# 87th & Greenwood

Early Design Guidance Meeting No. 2  
SDCI #3033218-EG  
June 3, 2019

WH Greenwood LLC

New Reveal Element Creates Transition to Upper Levels and Defines Main Residential Entry

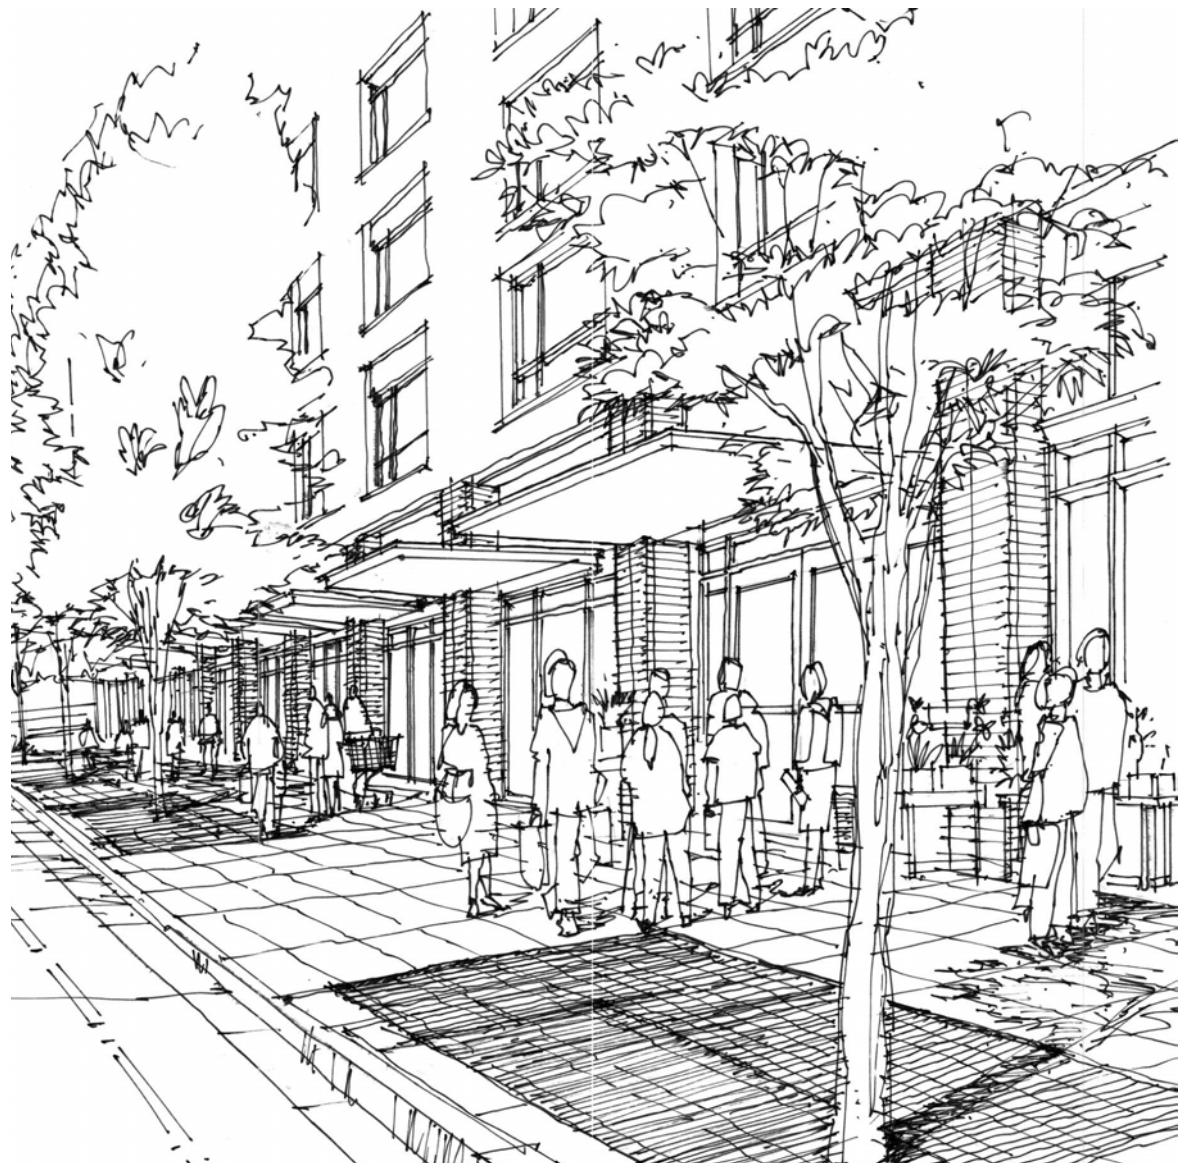
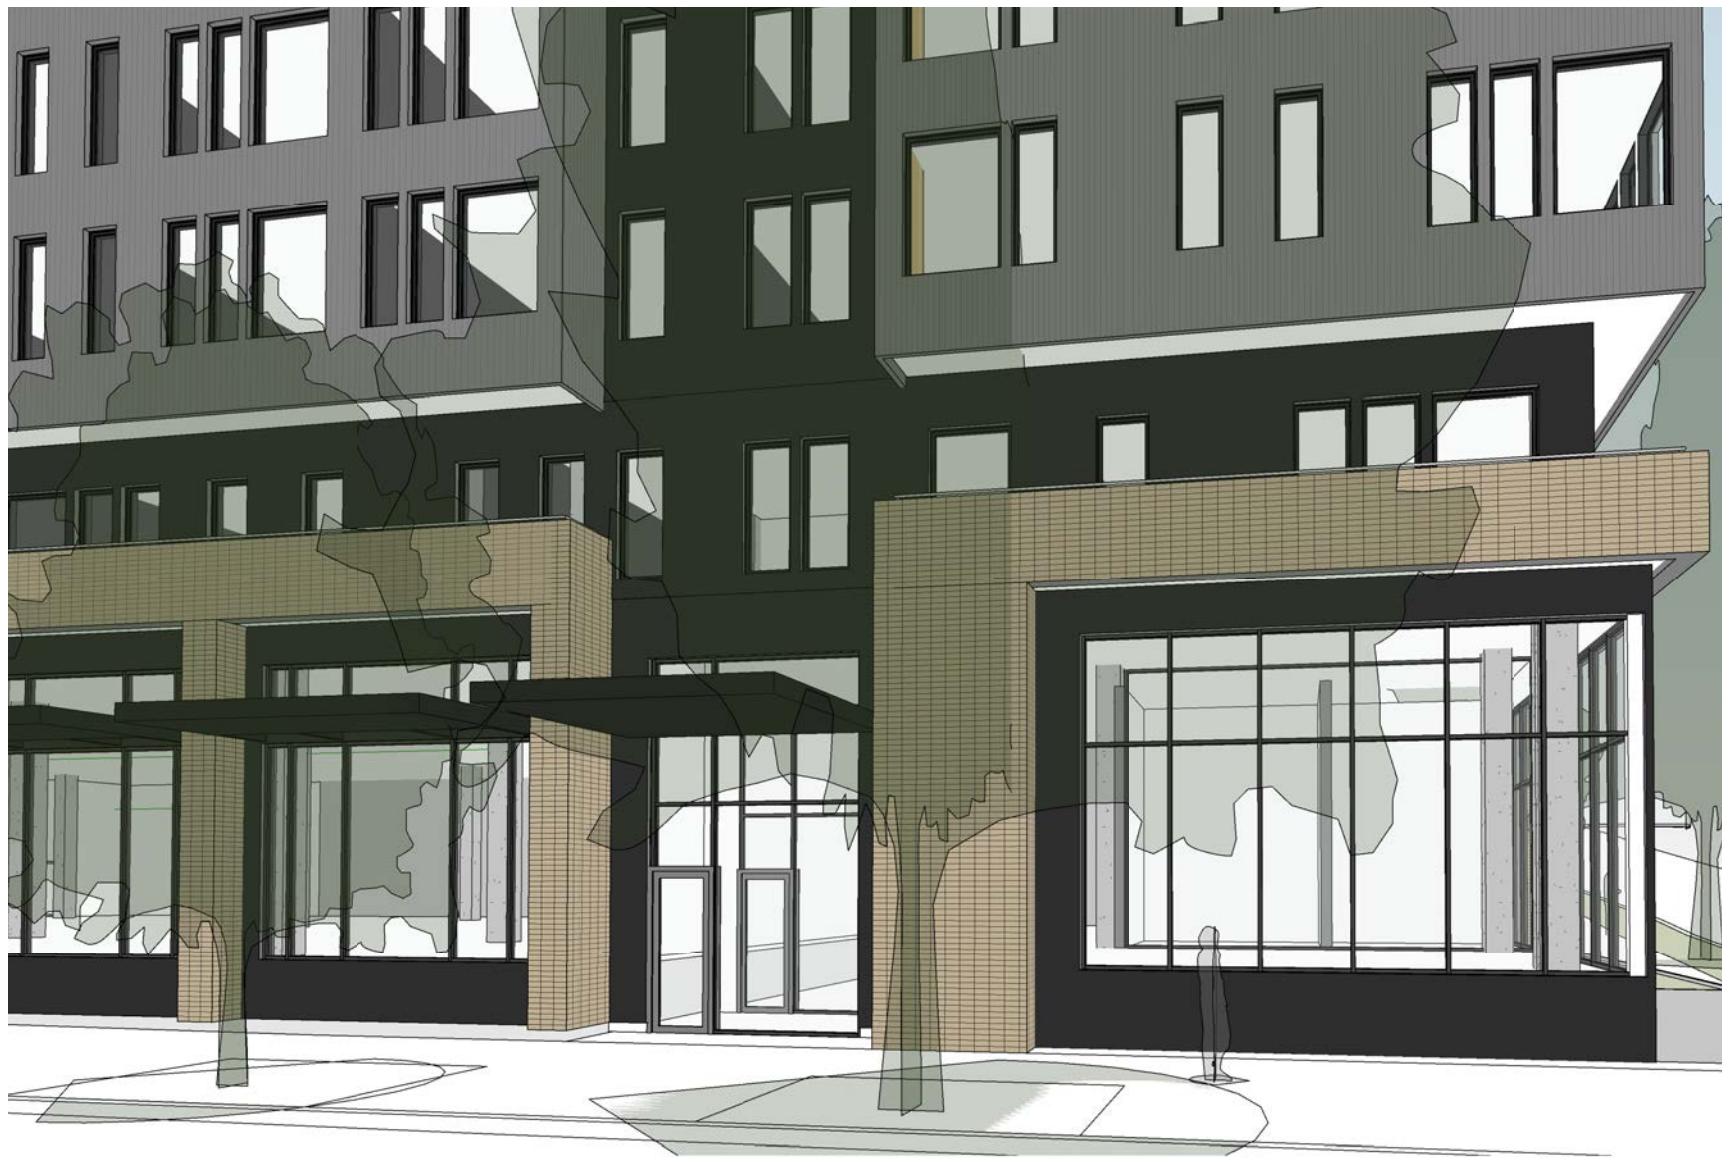
*Comment 4c. The Board voiced their appreciation for the character sketches showing pedestrian level experience along Greenwood Avenue but were concerned as to how the more traditional character at the street-edge would carry up to the more modern expression of the residential levels above.*

**Response:** A horizontal reveal has been added at Level 2 (at the west and central bars) and Level 3 (at the east bar) to better differentiate the street-level building "base" from the upper bulk of the building massing. The resulting parapet which crowns the street-level facades relates back to the historic character of the masonry facades lining Greenwood Ave N such as the beloved FlintCreek building.

## REVISED MASSING SCHEME

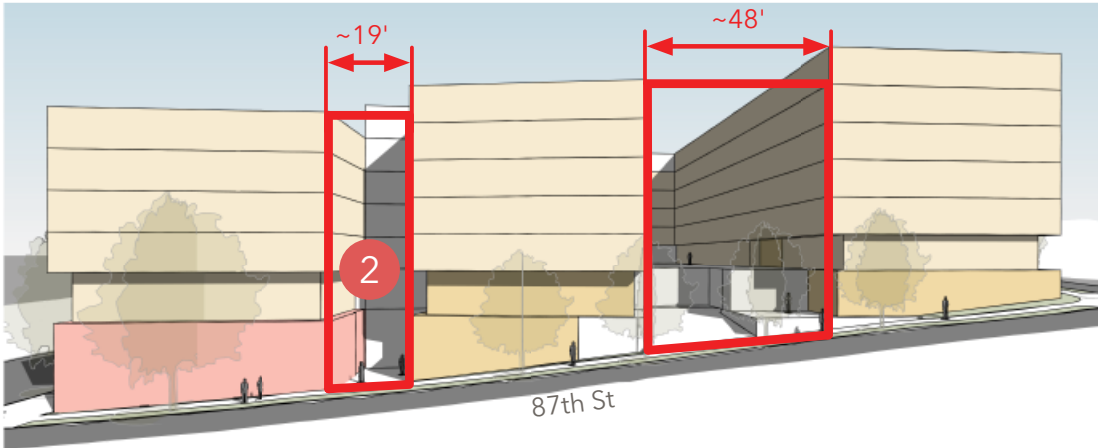
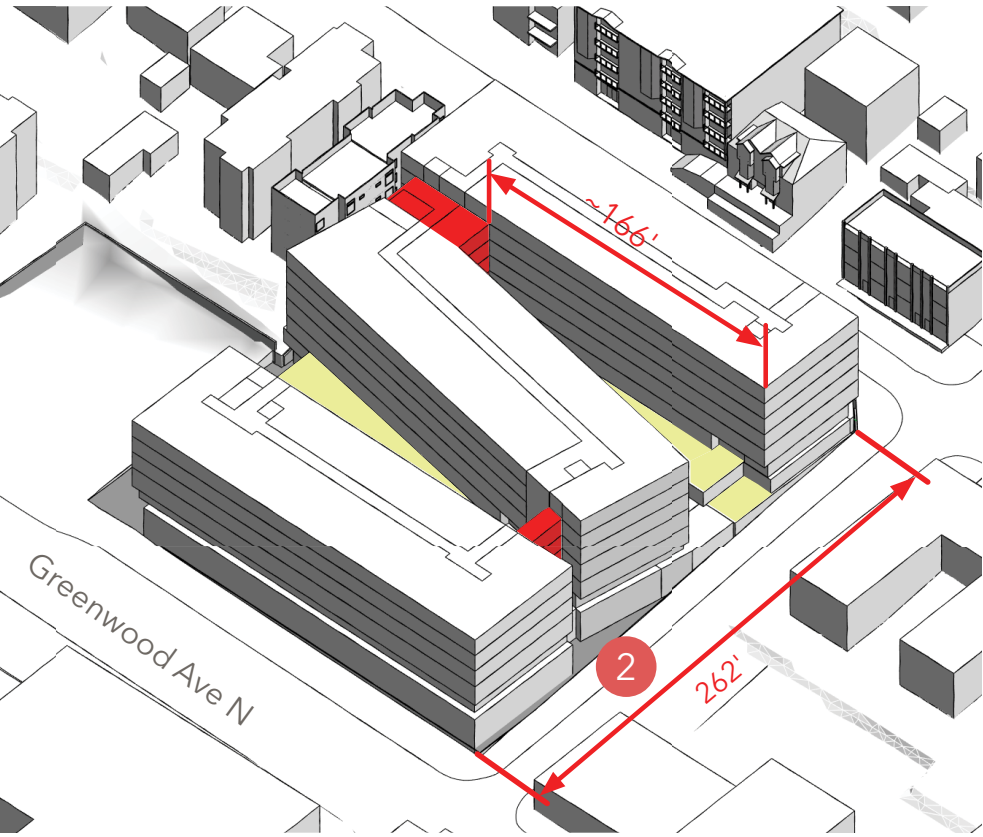
The composition and programming of pedestrian-level areas at this edge should create a vibrant, dynamic, and lively condition that is well-connected to the street.

The scale-mitigating massing shifts of the upper volumes should be clearly legible from pedestrian-level areas.

**Response:** Street-facing facades at N. 87th Street have been refined to respond to the DRB's comments, further activating the sidewalk by means of building entries, glazing and breaks in building massing offering visual relief.
- 2

**Response:** The break in building massing at the southwest "connector" stair has been extended down to the sidewalk level further emphasizing the legibility of the three-bar massing scheme from a pedestrian's point of view.
